**Re: Design Submission for Housing Development at Crown Square Development, Monivea Road, Galway (the “Development”) (the “Design Submission”) / 953699652.**

## Appendix A

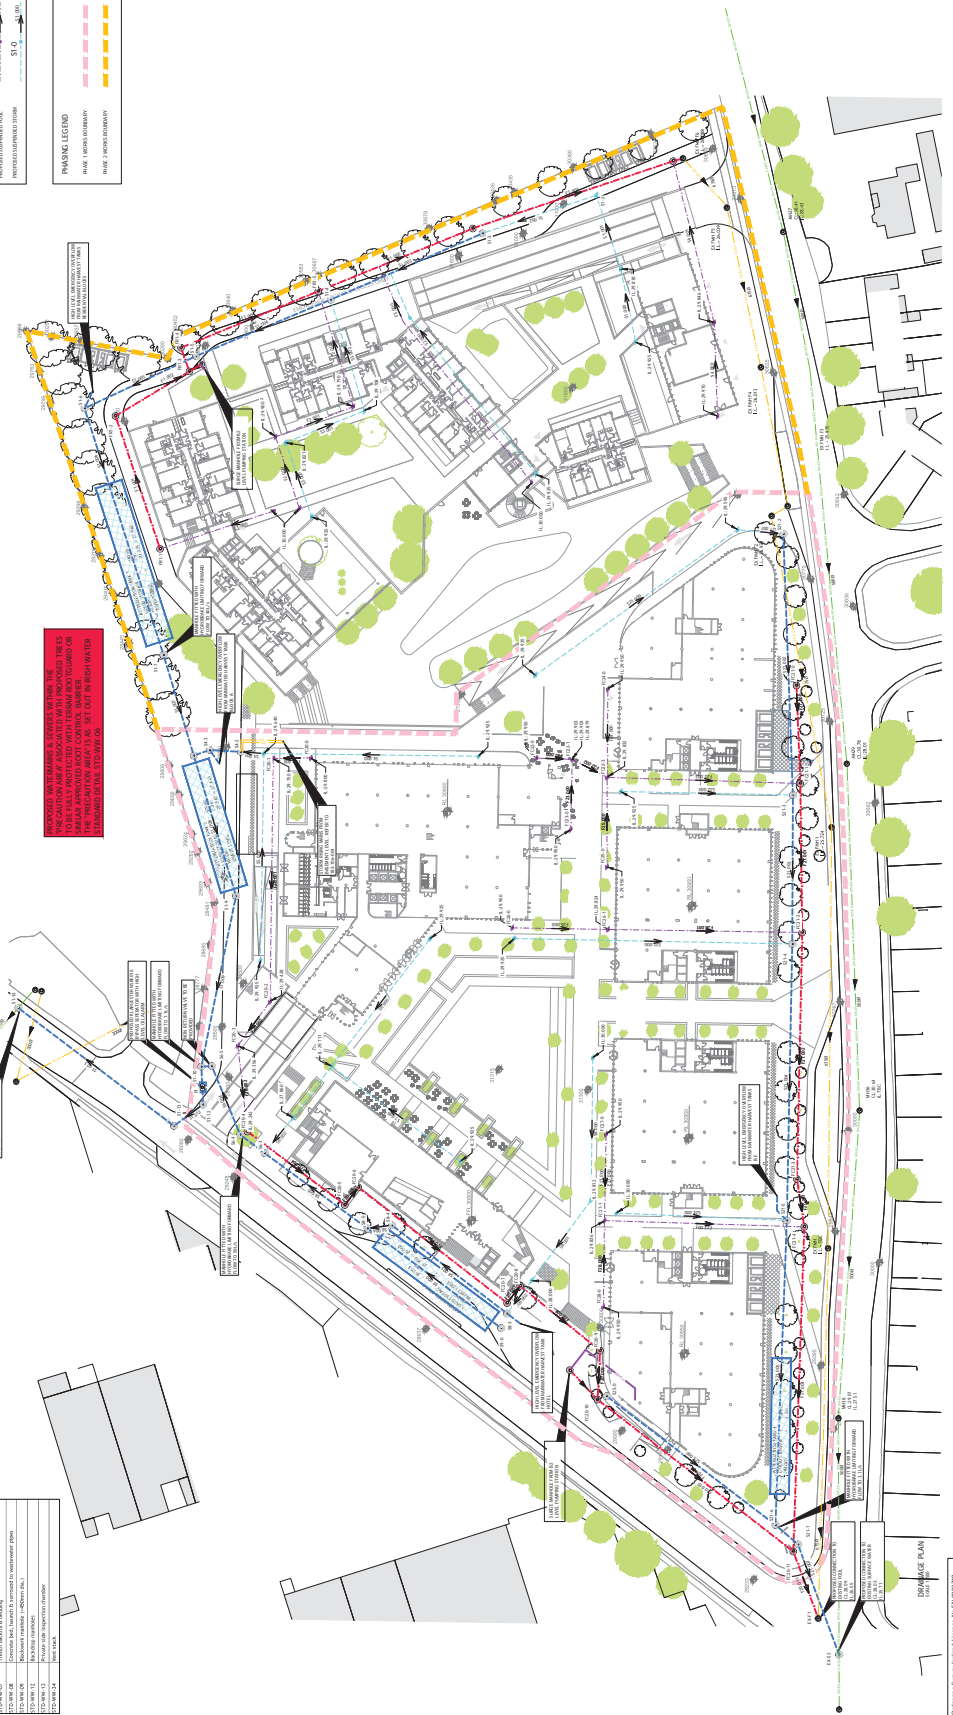
**\* Statement of Design Acceptance conditional that minimum cover to FC20-10 is increased to 500mm as per section 3.9.1 of the Wastewater Code of Practice**
